REV.
B

AS1895™/18

FLANGE, MALE, INTEGRAL, WELD RING,
TYPE I STANDARD PROFILE

FIGURE 1 - TYPICAL SECTION

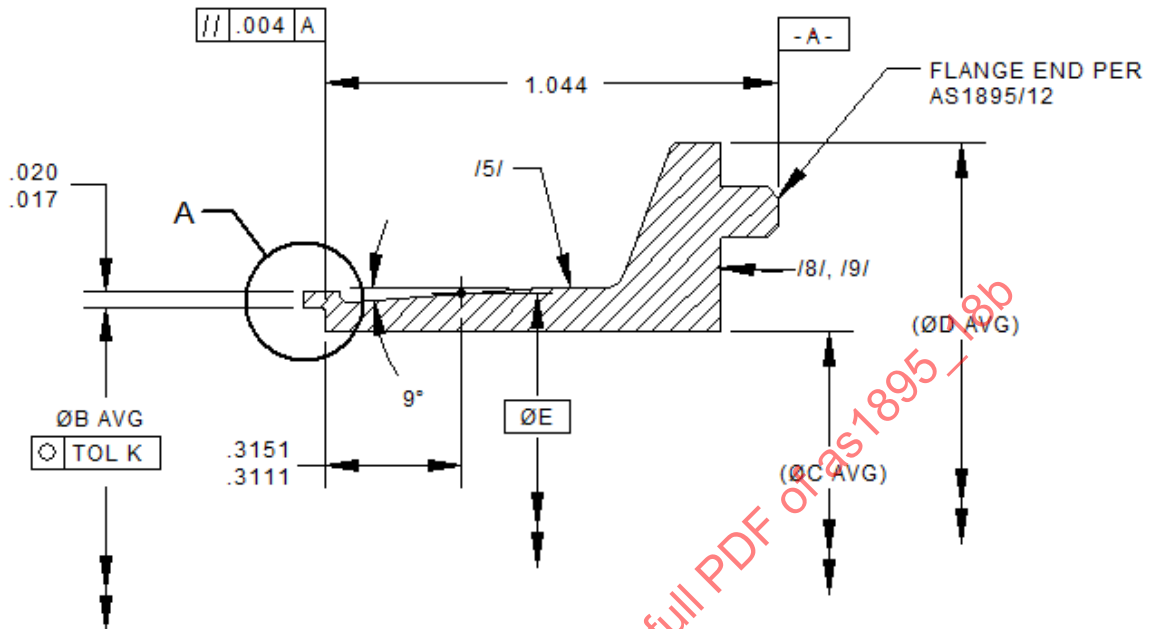
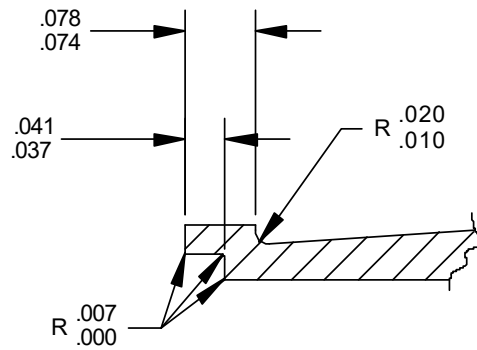
GRAPHICS REDRAWN. CIRCULARITY REQUIREMENT REMOVED FROM REFERENCE ØD AND GAGE ØE. PERPENDICULARITY REQUIREMENT REMOVED FROM REFERENCE ØC. TABLE 1 REDRAWN TO ADD "REF" TO DIM C AND D. NOTE 3 REVISED TO STATE CURRENT QML NOTE. GENERAL UPDATING OF SPECIFICATIONS BEING SPECIFIED HEREIN. CHANGE BAR NOTE REVISED. NOTE 17 ADDED.
